CITY OF MANTECA

SUBJECT: TUP-21-119 DR HORTON NORTH MAIN COMMONS LEASING OFFICE

The City of Manteca Planning Division has reviewed your Temporary Use Permit application for a leasing office. Your project application has been approved with the following conditions:

Construction Details

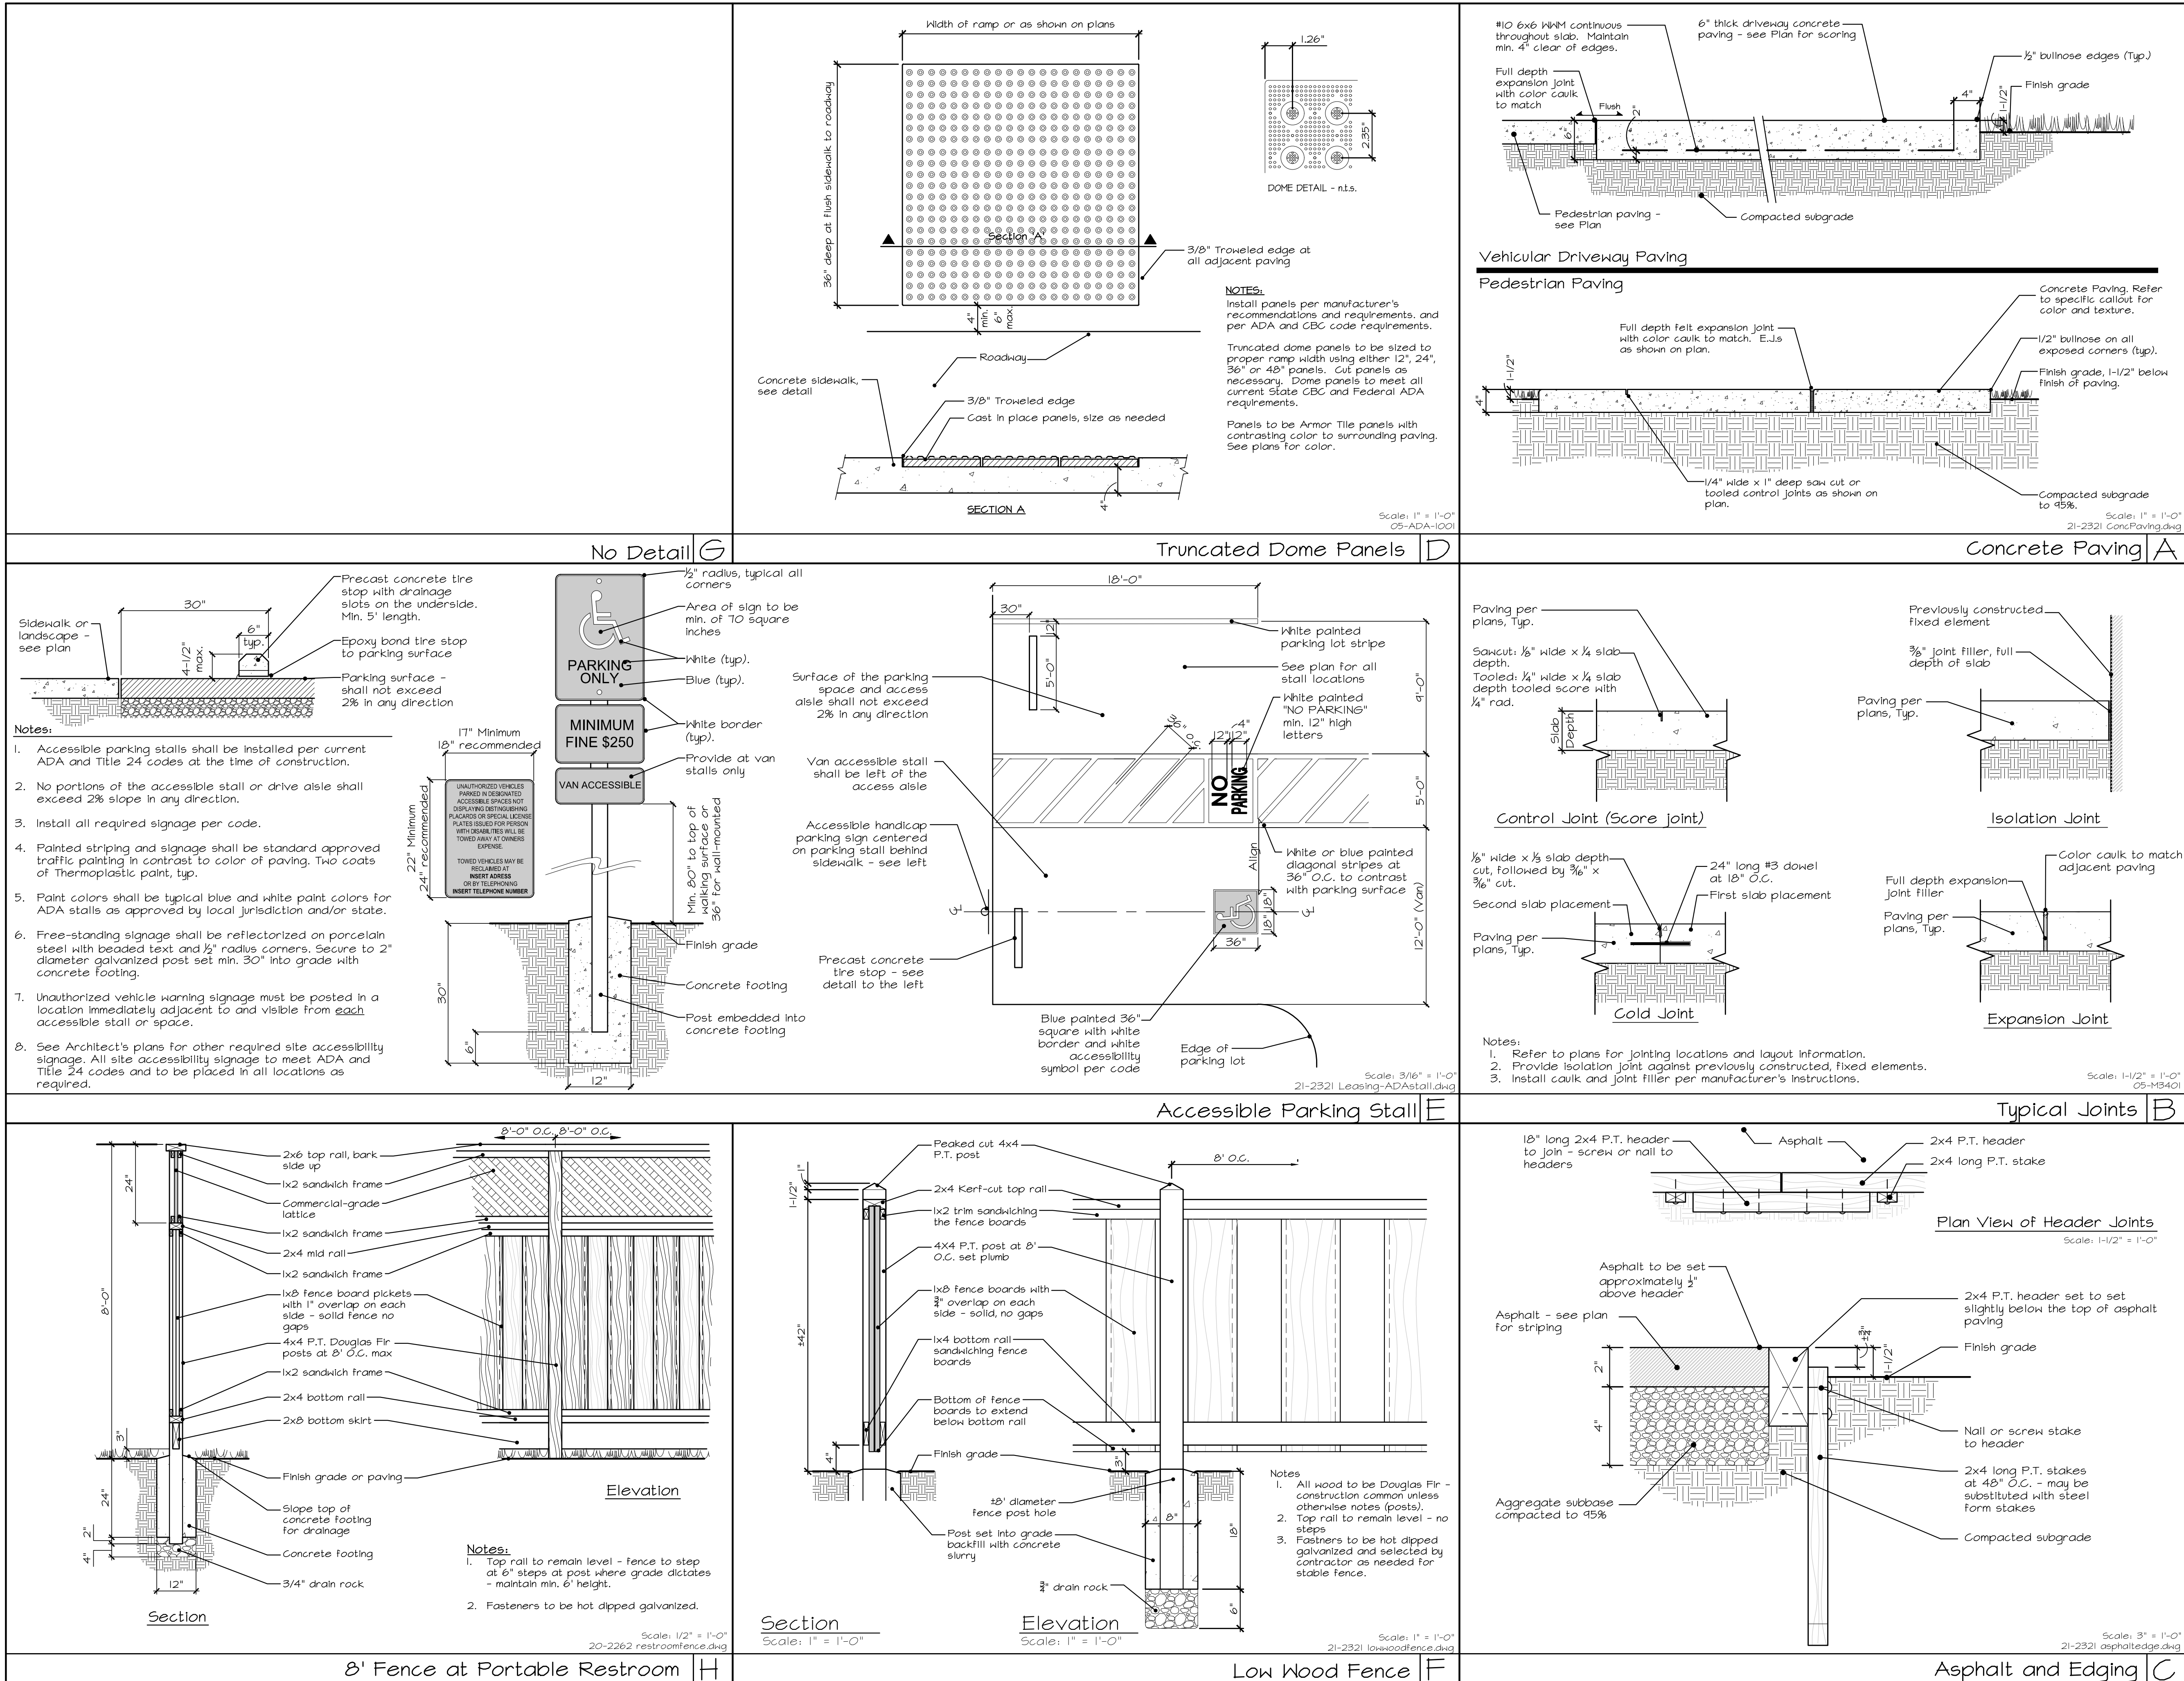
- Exception: Van parking spaces shall be permitted to be 108 inches (9') wide minimum where the access aisle is 96 inches (8') wide minimum.
13. Complete the information for the tow-away sign as follows: (Detail E/L2.1)

- "Unauthorized" vehicles parked in designated accessible spaces not displaying distinguishing placards or special license plates issued for persons with disabilities will be towed away at the owner's expense. Towed vehicles may be reclaimed at: **City of Manteca Police Department** or by telephoning **(209) 456-8101**."
